ADDENDUM ONE QUESTIONS and ANSWERS

RE: Addendum for Invitation to Bid Number 5723 OF
to be opened December 15, 2017 at 2:00 p.m. Central Time

Attachment 1

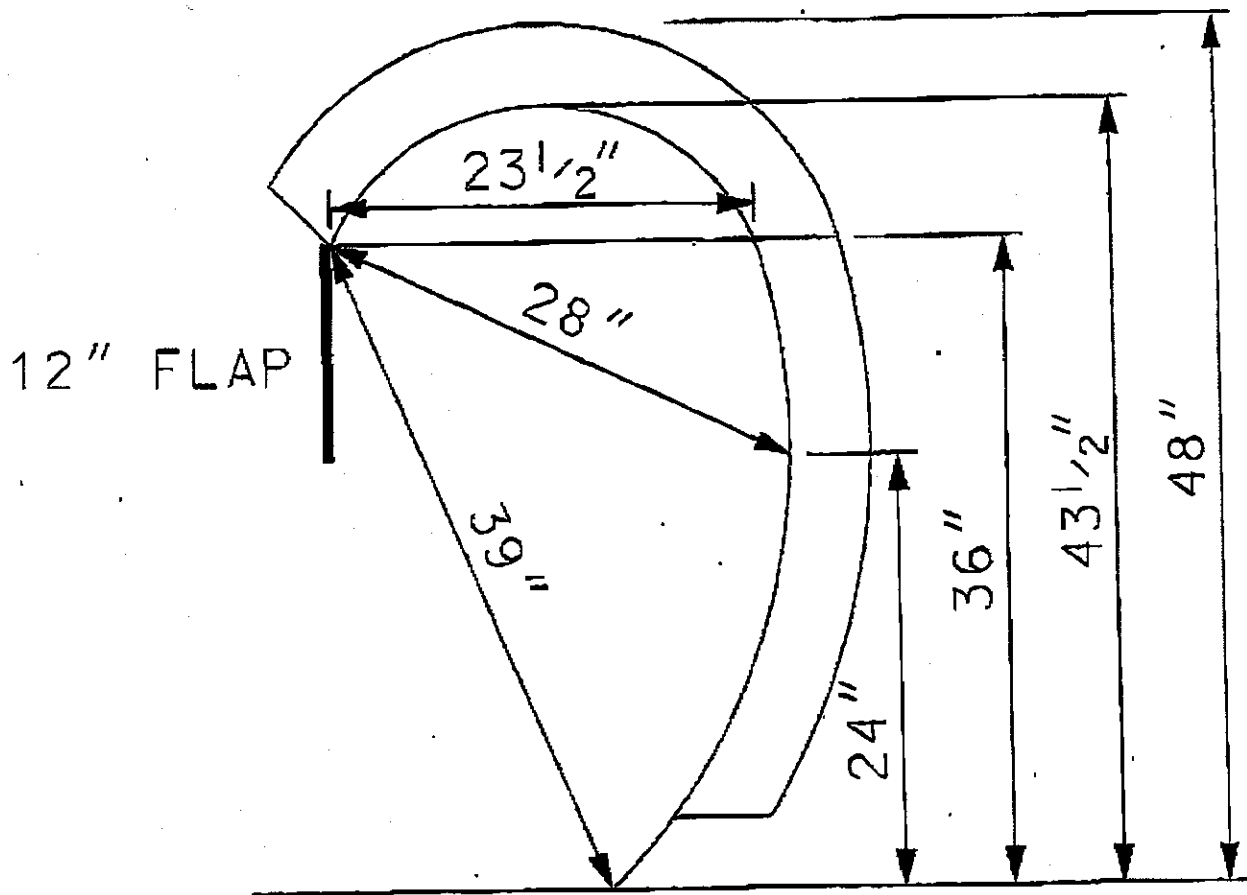
2.	C.2.	26	<p>Inverted "J" design per the drawing attached. Attachment 1.</p> <p>Is the Henderson poly J plow shape acceptable? (see attached).</p>	<p>No, please comply with specifications as written.</p>
